Office Action Summary

10/799,939

WORRICK ET AL.

DETAILED ACTION

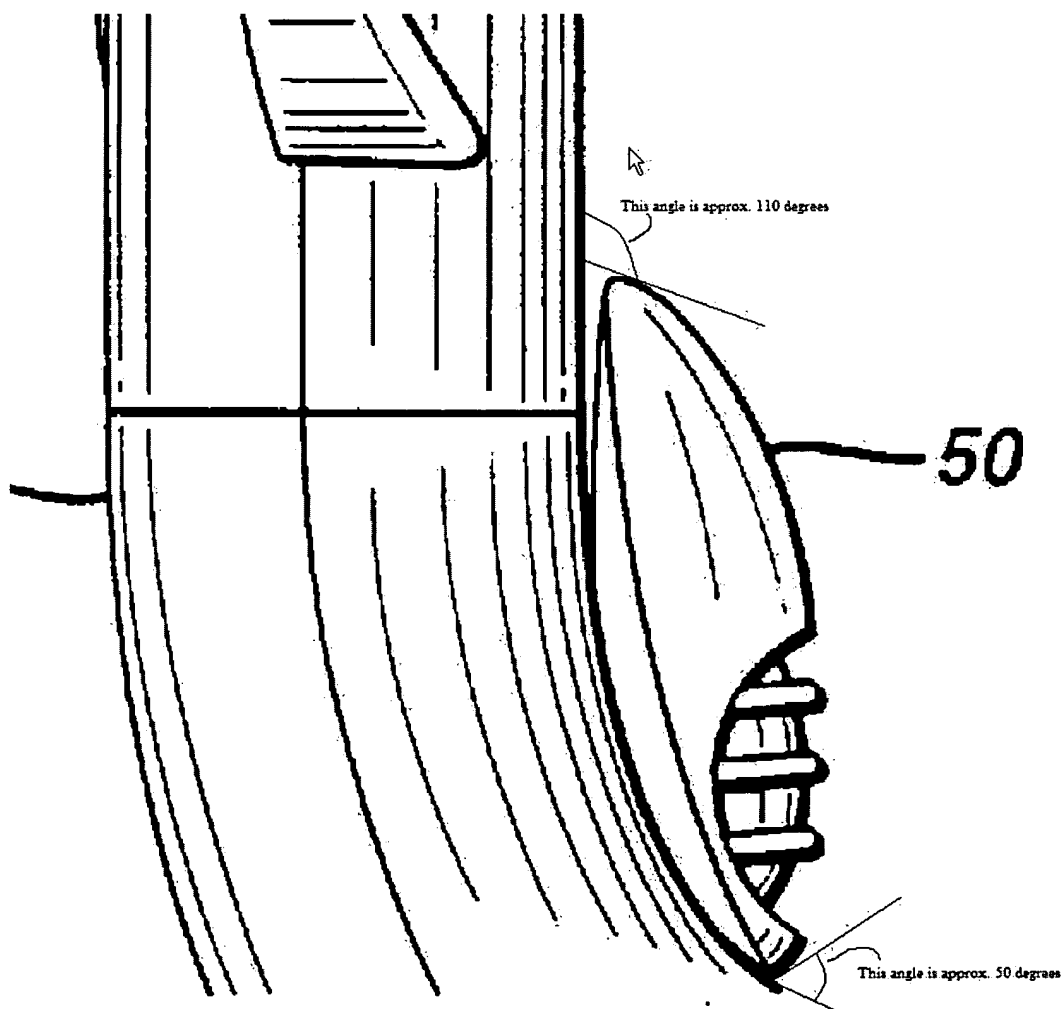
Regarding claim 7 Apprille'071 discloses that the edge of the canopy contacts the handle casing having an angle of no greater than 110 degrees. This is because the angle formed between the button and the handle casing varies and is at a maximum in the front center region of the canopy, which at no time is greater than 110 degrees (#50 is in contact with #12, figures 16 & 17). See the figure below.

Regarding claims 8, 10, 19 and 21 Apprille'071 discloses that the edge of the canopy of the shaving razor disclosed above contacts the handle casing having an angle which varies around the periphery and has a maximum at "a center region" of the canopy. This is seen in the figure above, from Figure 18 of Apprille'071.
